Re: **Request for Information**
Docket No. CWA-IR-13-013
United Talmudic Academy of Kiryas Joel (UTA of KJ) - Bakertown Road, Kiryas Joel NY
NPDES Tracking Number: NYU400900
Tax Map Section 310- Block 1- Lots 4.14, 4.16, 4.171 Orange County, Town of Monroe, Village of Kiryas Joel

Water Compliance Inspection Report

On June 13, 2013, the United States Environmental Protection Agency (EPA) conducted a Reconnaissance Inspection at the UTA of KJ Inc.'s United Talmudical Academy of Kiryas Joel Boys School construction site, located off of Bakertown Road in Kiryas Joel, New York, Orange County (Site) (See Aerial Image Attachment 2). The site is approximately 100 feet north of the Village of Kiryas Joel's Department of Public Works Garage. Murray Lantner of EPA's Division of Enforcement and Compliance Assistance, Water Compliance Branch (DECA-WCB) conducted the inspection along with EPA intern Thomas Parel.

DSCN1296.JPG
06/13/2013

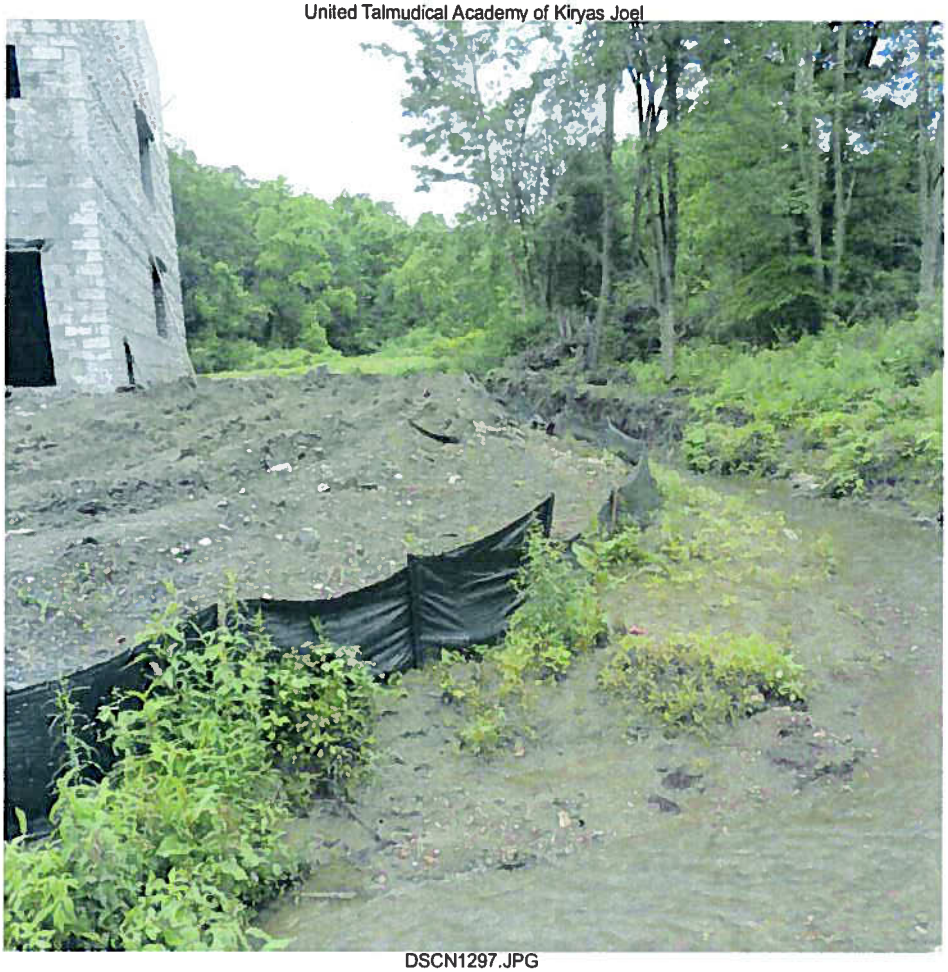
3. An entry road to the United Talmudical Academy of Kiryas Joel was built across Highland Brook at the southwest portion of the site. Culverts were placed through the road to convey the stream from one side of the road to the other (see photograph 1296). During and after rain events, runoff along with sediments are able to flow into Highland Brook by going around these silt fences (see photographs 1294, 1295, 1340). These silt fences need to be secured in order to prevent discharge of pollutants.

DSCN1304.JPG
06/13/2013

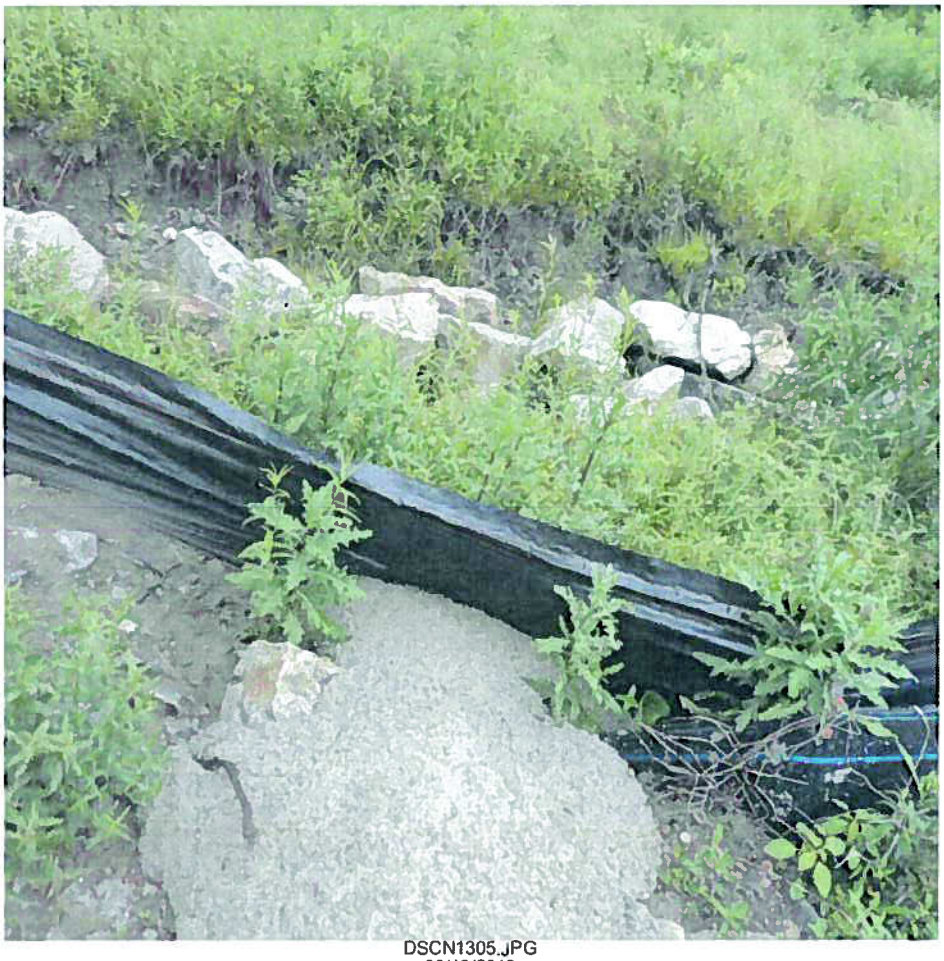
5. As shown in photos 1303 to 1305, there was apparent concrete washout from the site adjacent to a tributary of Highland Brook on the eastern side of the site. Part

B.1.j requires proper pollution prevention measures for the disposal of construction waste to prevent stormwater pollution.

DSCN1340.JPG
06/13/2013

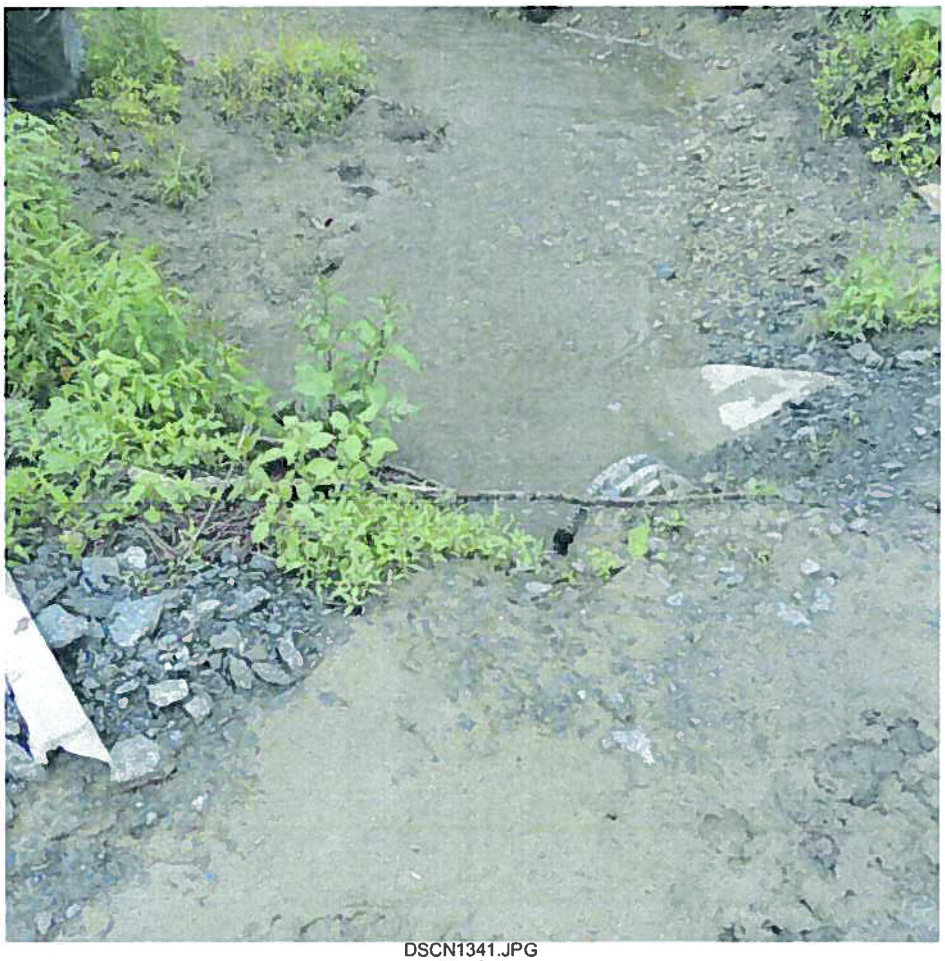
DSCN1340	6/13/2013	Multiple water runoff pathways are able to carry sediments under and around the silt fence into the flowing Highland Brook at the site entrance.
DSCN1341	6/13/2013	Signs of sediment being washed around the silt fence into Highland Brook are visible at the site entrance.
